## **RB251-06/07**

### **R703.2**

**Proponent:** Ronald Majette, United States Department of Energy

## **RB252-06/07**

**FIGURE R703.7.3.2  
MASONRY VENEER GARAGE DOOR OPENING**

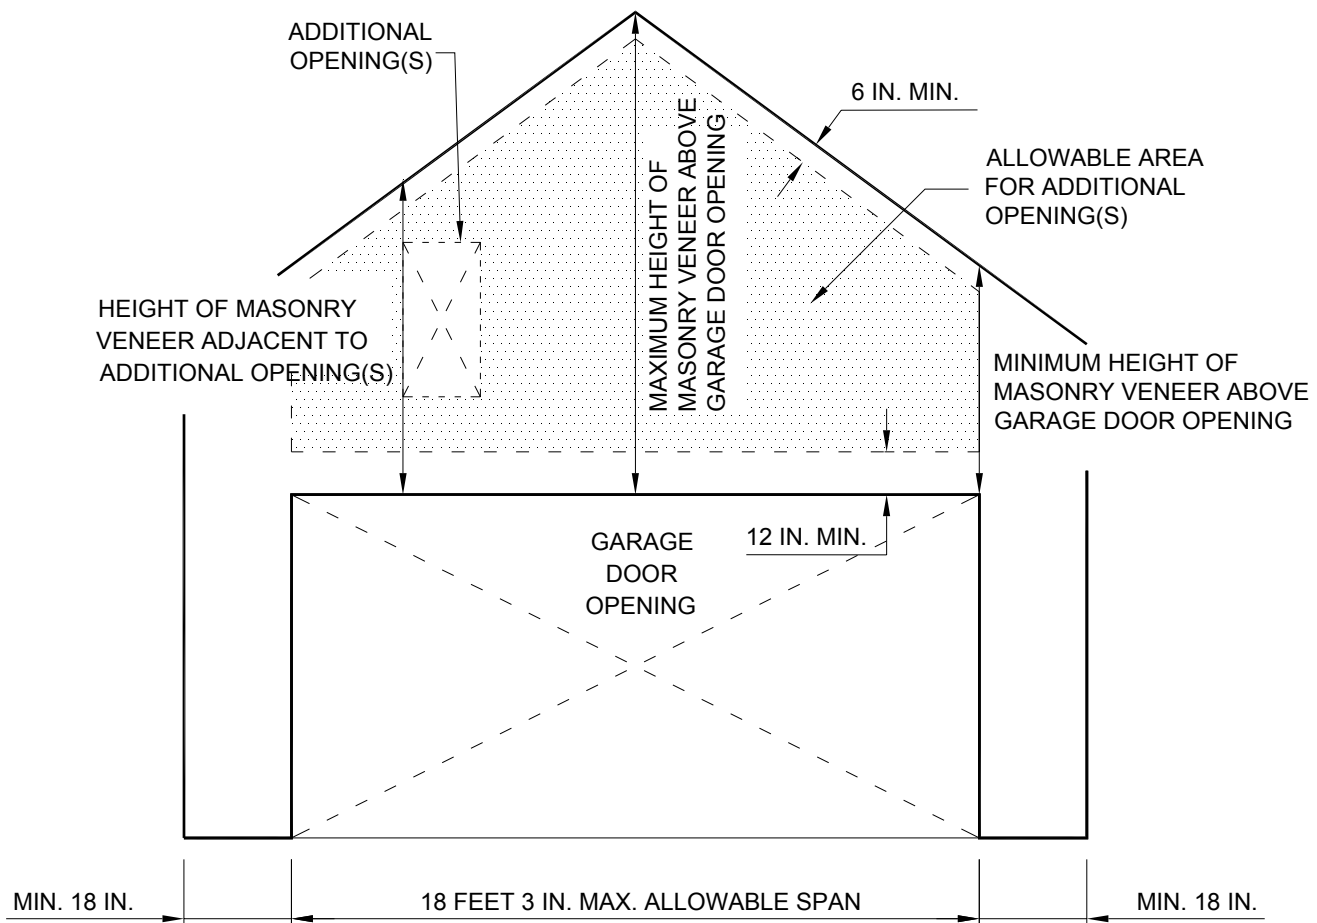
**R703.7.3.2** The allowable span shall not exceed 18 feet 3 inches (5562 mm) and shall be constructed to comply with Table R703.7.3.2, Figure R703.7.3.2 and the following:

1. Provide a minimum length of 18 inches (457 mm) of masonry veneer on each side of garage door opening as shown in Figure R703.7.3.2.
2. Provide a minimum 5 inch x 3½ inch x 5/16 inch (127 mm x 89 mm x 7.9 mm) steel angle above the garage door opening and shore for a minimum of 7 days after installation.

4. Additional opening(s) may be placed above garage door opening. Such openings shall be sized according to Table R703.7.3.2 and located within the allowable area for additional opening(s) shown in Figure R703.7.3.2. The allowable area for additional opening(s) shall be within 12 inches (305 mm) above the garage door opening and 6 inches (152 mm) below the top of masonry veneer as shown in Figure R703.7.3.2. Lintels supporting masonry veneer above additional opening(s) shall be sized according to Table R703.7.3.1.

This change introduces a means to span large masonry veneer openings using horizontal joint reinforcement and a steel angle. It builds on RB186-04/05 by presenting the concept in a clear, concise manner. While RB 186-04/05 was recommended for approval by the Residential Committee, some testifying at the final hearings felt the language could be more clearly presented. This change keeps the reference to the existing Lintel Table while giving an alternate means of spanning large openings.
